# Access Compliance Report

## Public Rights-of-Way

Intersection ID: 3176	Main Street: OLD_TIMBER_RD	Cross Street: SUTTERS_HILL_CT	Location: W
ADA ID: 3CE8F1153225	Ramp Type: Perp	Initial Pass/Fail: Fail	Overall Compliance: No
Severity Score: 25			
Codes/Mitigation Info/Possible Solution		Field Measurements/Component Compliance

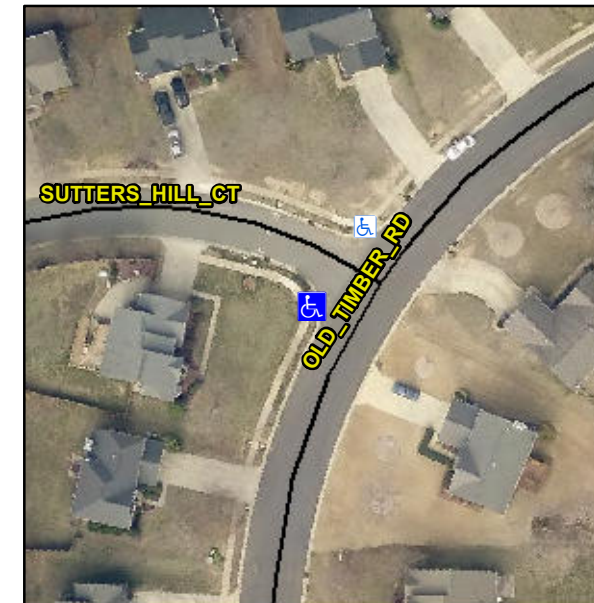
**Not Found, R304.5.3**

Compliance	Description	Data	Compliance	Description	Data
N/A	Ramp Length (in)	48.0	Yes	Ramp Slope (%)	5.7
Yes	Ramp Width (in)	52.5	No	Ramp XSlope (%)	7.7
N/A	Flare Type LT	N/A	N/A	Flare Type RT	N/A
N/A	Flare Slope LT (%)	N/A	N/A	Flare Slope RT (%)	N/A
N/A	Flare Traversable LT?	N/A	N/A	Flare Traversable RT?	N/A
N/A	Landing Length (in)	N/A	N/A	DWS Provided?	N/A
N/A	Landing Width (in)	N/A	N/A	DWS Contrast?	N/A
N/A	Landing Slope (%)	N/A	N/A	DWS Length (in)	N/A
N/A	Landing X Slope (%)	N/A	N/A	DWS Full Width?	N/A
N/A	Landing Curb? (Y/N)	N/A	N/A	DWS Offset (in)	N/A
N/A	Shared Landing?	N/A			
N/A	Gutter Ponding?	N/A	N/A	Gutter Slope (%)	N/A
N/A	Gutter Lip Ht (in)	N/A	N/A	Gutter X Slope (%)	N/A
N/A	Painted X Walk1?	No	N/A	Painted X Walk2?	N/A
	X Walk 1 Direction	To NE		X Walk 2 Direction	N/A
N/A	X Walk 1 Width (in)	N/A	N/A	X Walk 2 Width (in)	N/A
	X Walk 1 Slope (%)	7.5		X Walk 2 Slope (%)	N/A
	X Walk 1 X Slope (%)	1.7		X Walk 2 X Slope (%)	N/A

**Remove & Replace Entire Ramp.**
